**INTERIM REPORT
OF THE
DOE TYPE B
INVESTIGATION GROUP**

**LICENSING
CORRESPONDENCE**

**NRC REGION III
FILES**

Figure 4
WASTE ENCAPSULATION AND STORAGE FACILITY (WESF) CAPSULE

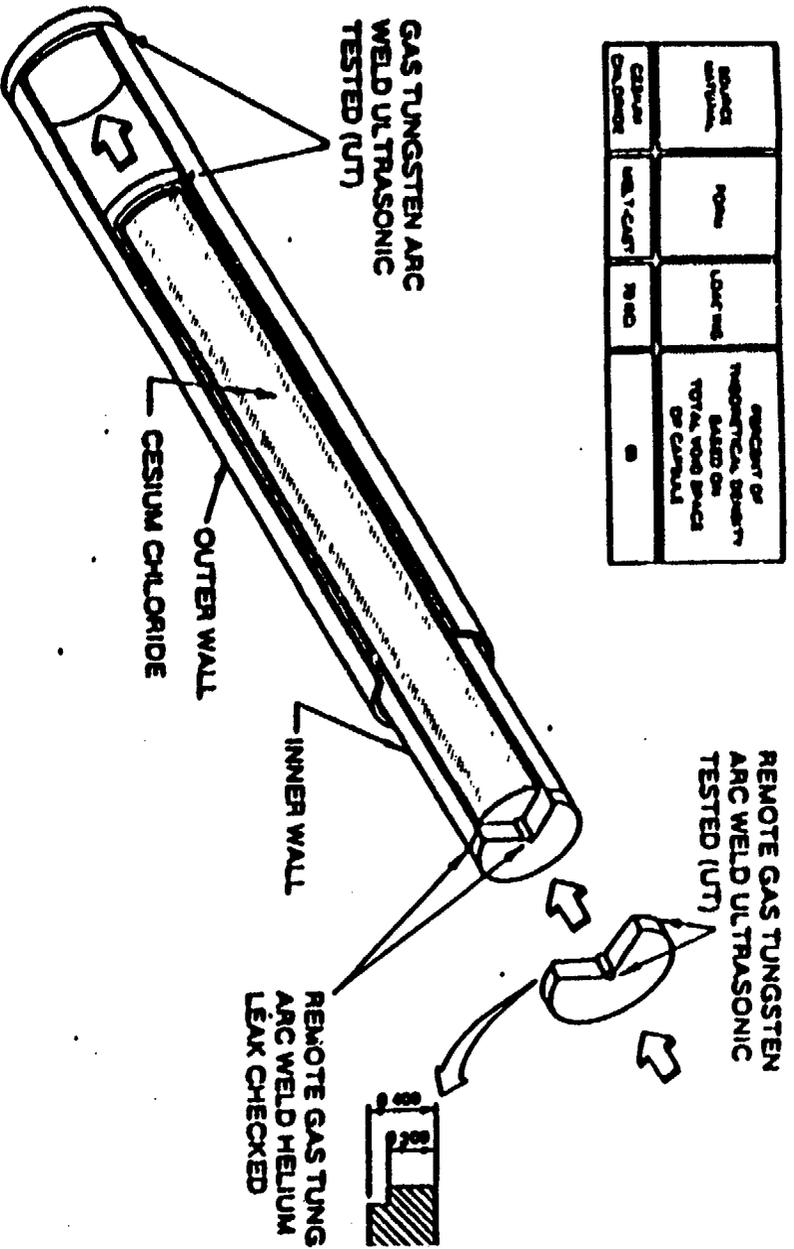
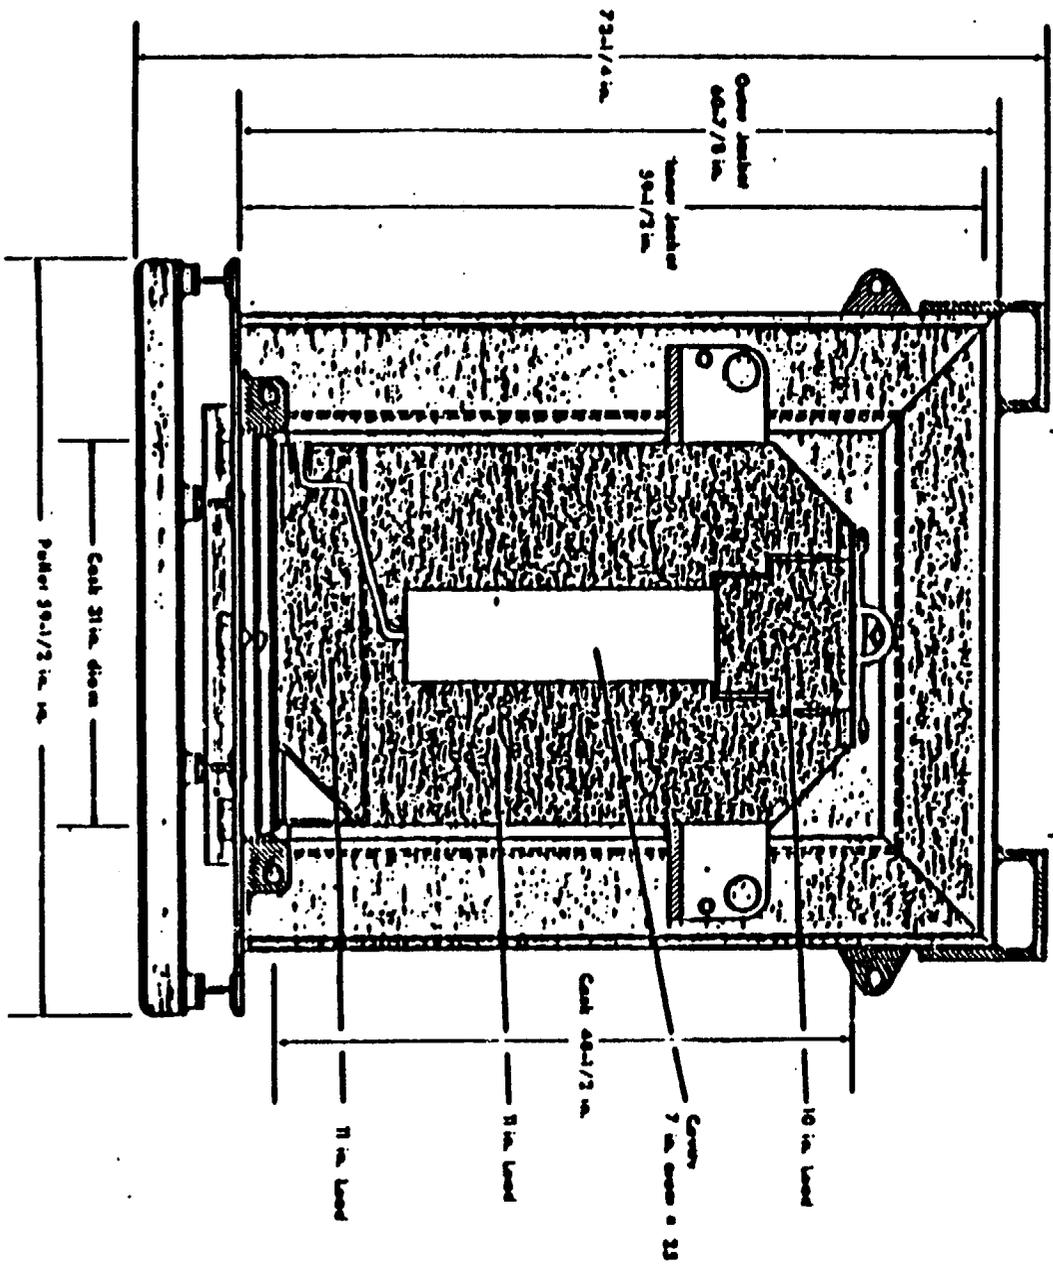
The cesium source elements will be the WESF capsules produced by the DOE at Richland, WA. A drawing of the WESF capsule is included for reference. Each source will be serialized for identification by the supplier.

FIGURE 1. CESIUM-137 WEST CAPSULE

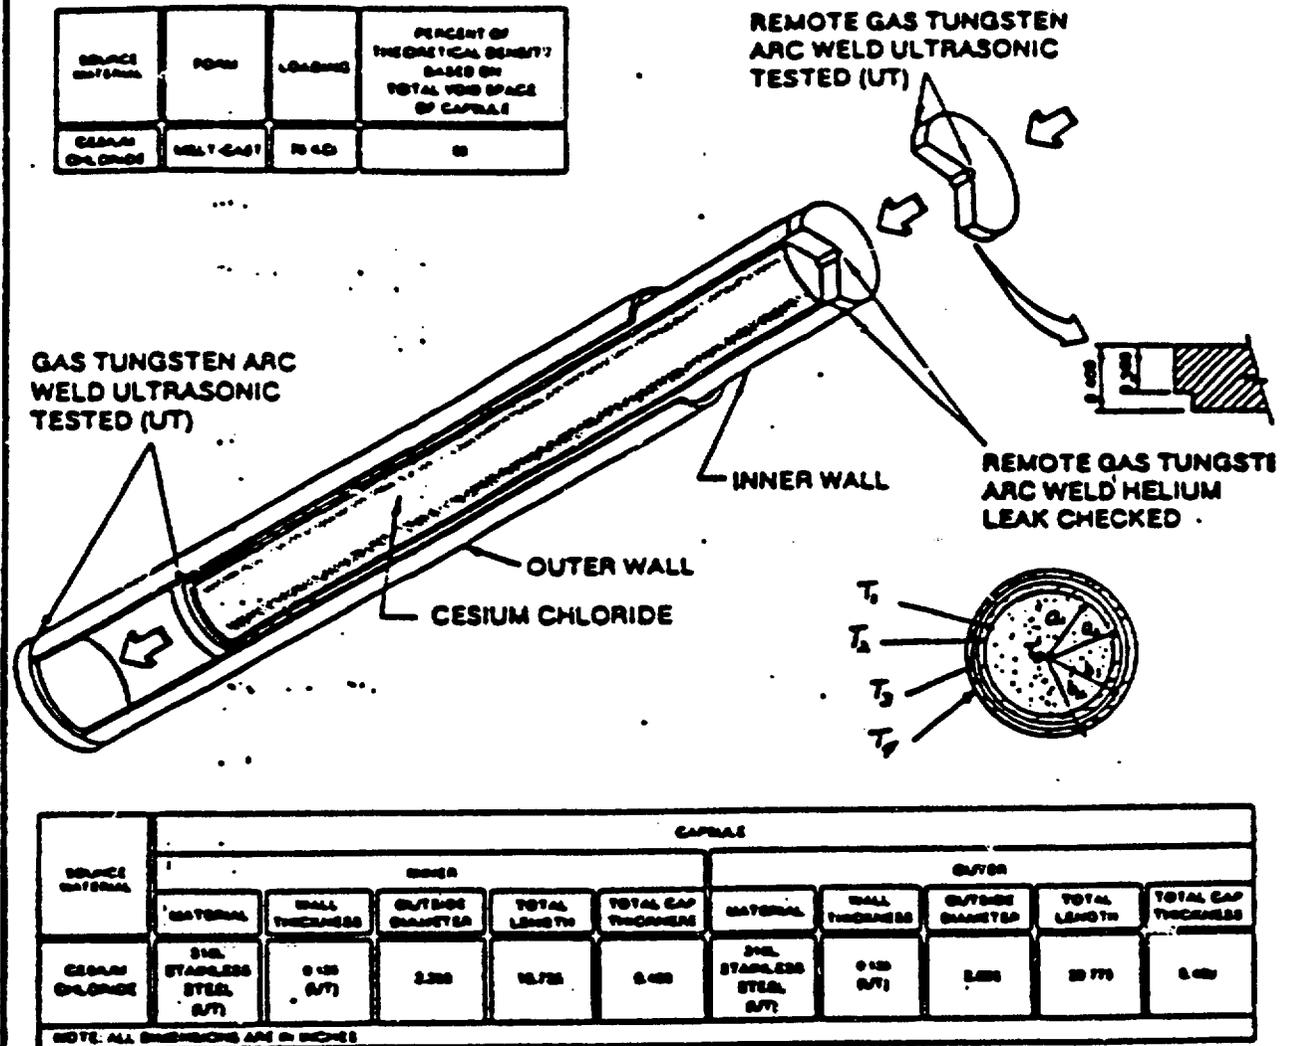
A theoretical model is used to estimate the temperature distribution within a cesium capsule and predict the temperature at the surface of a cobalt capsule. Studies performed at Battell, Northwest and Sandia provide information on temperature within a cesium capsule. Comparison of theoretical results with the available data base for cesium provides tie down points to determine the efficacy of the model and estimate calculational uncertainties.

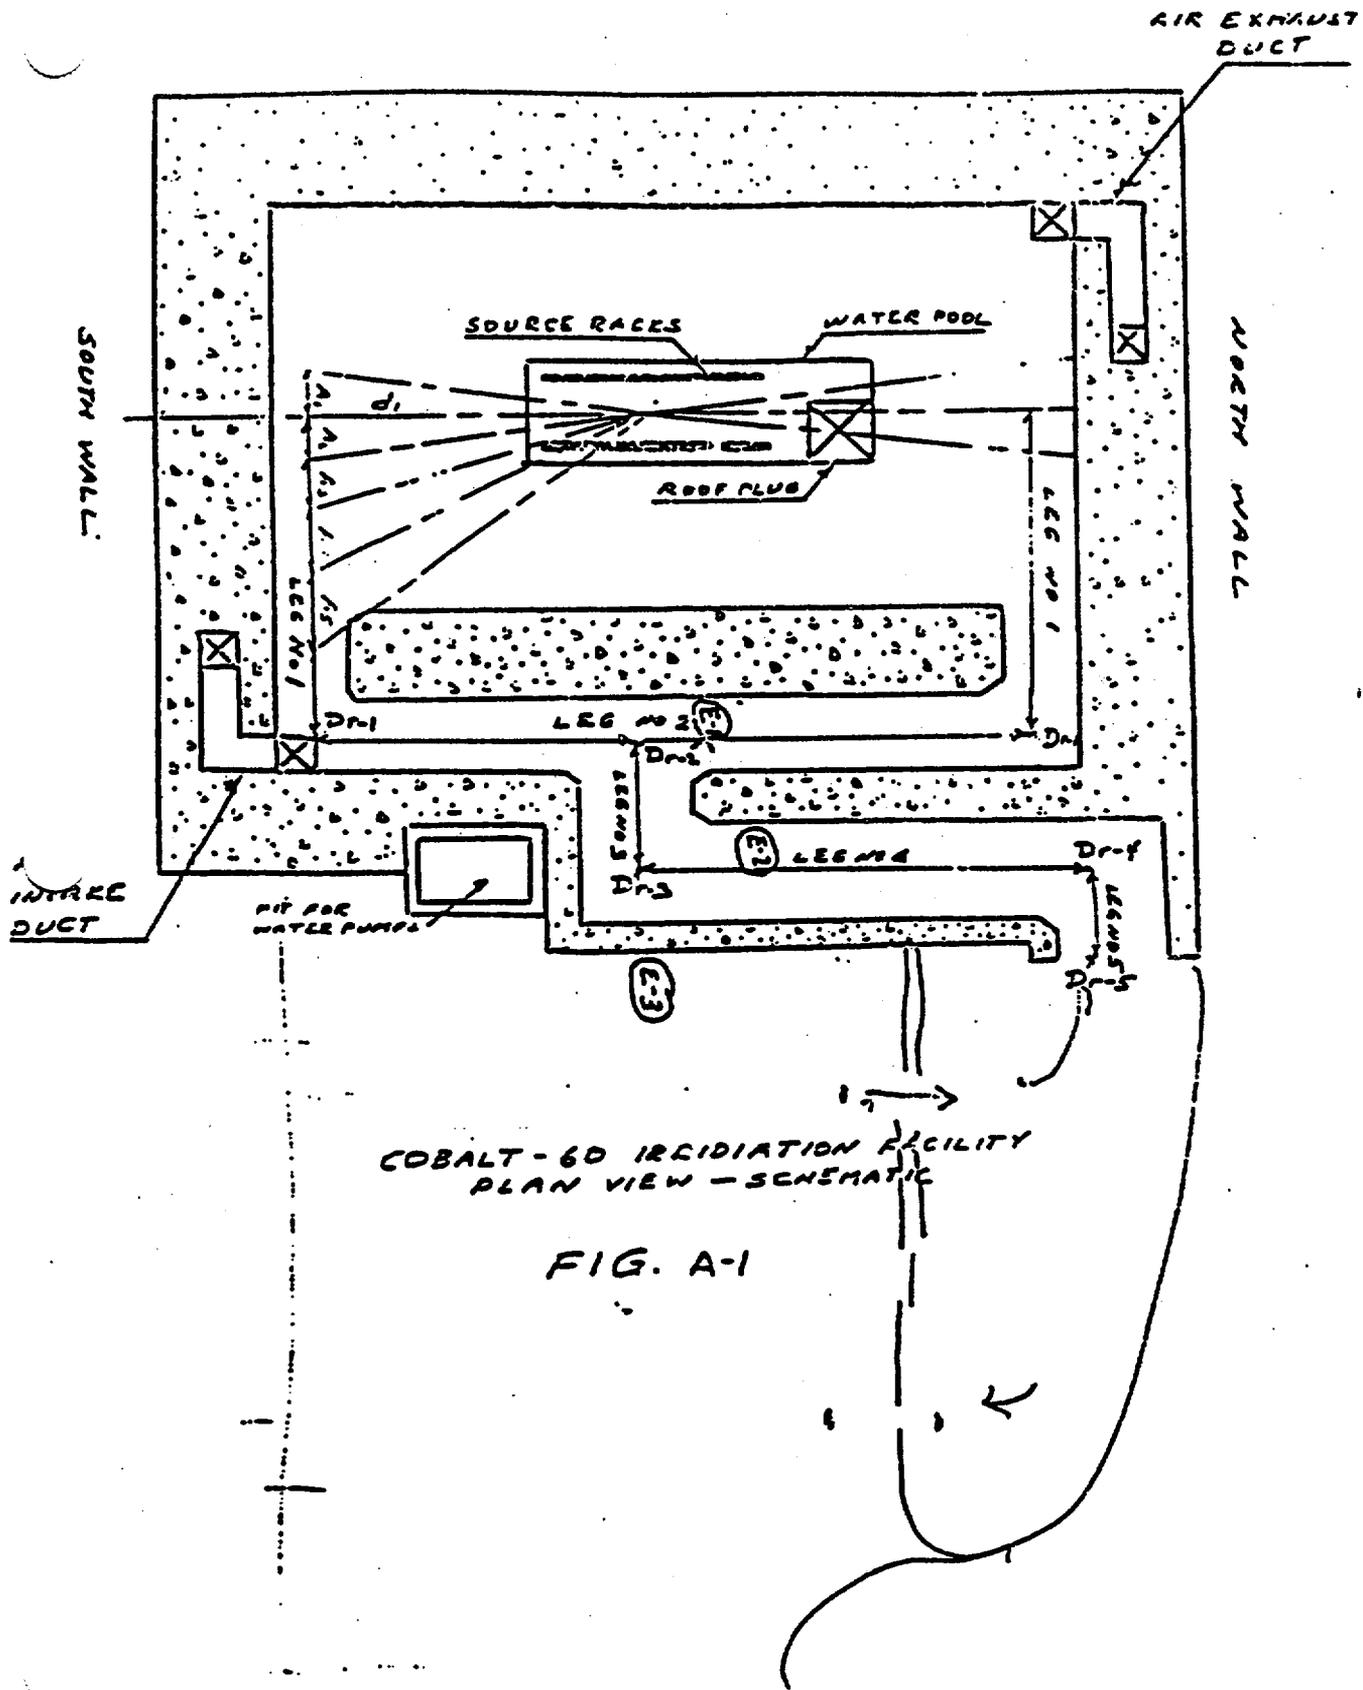
Drawings No. 503-600 and 503-601 show the shielding proposed for the irradiation facility. A schematic of the plan view (RSI 503-600) is included as Figure A-1. The computed exposure rates are summarized below:

The exposure rate of 42.1 mR/hr behind the east maze wall is located within leg 2 at point E-1. At locations E-2 and E-3 the leakage dose rates are reduced to 0.0014 mR/hr and 0.11 mR/hr respectively. Refer to Figure A-1.
